Access Compliance Report

Public Rights-of-Way

Intersection ID: 43510	Main Street: MULBERRY_POND_DR	Cross Street: N/A	Location: NW
ADA ID: 1218E7717D3B	Ramp Type: PerpDiag	Initial Pass/Fail: Fail	Overall Compliance: No
		Severity Score: 60

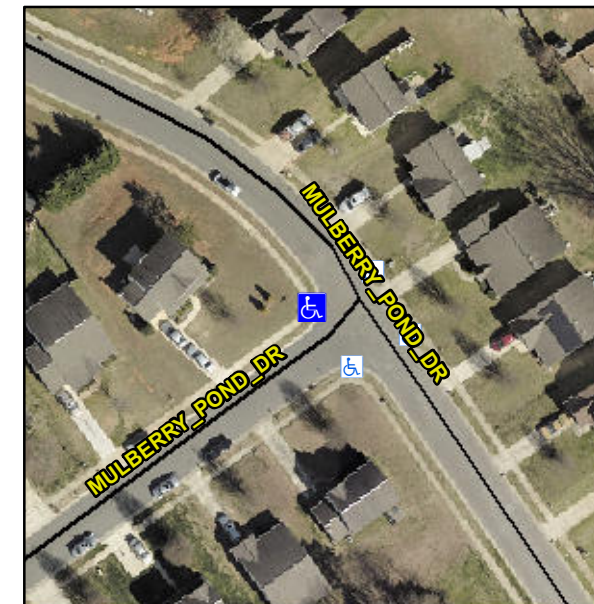
Not Found, R304.5.1, R304.5.3

Compliance	Description	Data	Compliance	Description	Data
N/A	Ramp Length (in)	48.0	Yes	Ramp Slope (%)	5.4
No	Ramp Width (in)	30.0	No	Ramp XSlope (%)	8.9
N/A	Flare Type LT	N/A	N/A	Flare Type RT	N/A
N/A	Flare Slope LT (%)	N/A	N/A	Flare Slope RT (%)	N/A
N/A	Flare Traversable LT?	N/A	N/A	Flare Traversable RT?	N/A
N/A	Landing Length (in)	N/A	N/A	DWS Provided?	N/A
N/A	Landing Width (in)	N/A	N/A	DWS Contrast?	N/A
N/A	Landing Slope (%)	N/A	N/A	DWS Length (in)	N/A
N/A	Landing X Slope (%)	N/A	N/A	DWS Full Width?	N/A
N/A	Landing Curb? (Y/N)	N/A	N/A	DWS Offset (in)	N/A
N/A	Shared Landing?	N/A			
N/A	Gutter Ponding?	N/A	N/A	Gutter Slope (%)	N/A
N/A	Gutter Lip Ht (in)	N/A	N/A	Gutter X Slope (%)	N/A
N/A	Painted X Walk1?	No	N/A	Painted X Walk2?	No
	X Walk 1 Direction	To S		X Walk 2 Direction	To E
N/A	X Walk 1 Width (in)	N/A	N/A	X Walk 2 Width (in)	N/A
	X Walk 1 Slope (%)	2.2		X Walk 2 Slope (%)	0.6
	X Walk 1 X Slope (%)	1.1		X Walk 2 X Slope (%)	4.2

Remove & Replace Curb Ramp With Two New Directional Ramps or Equivalent.
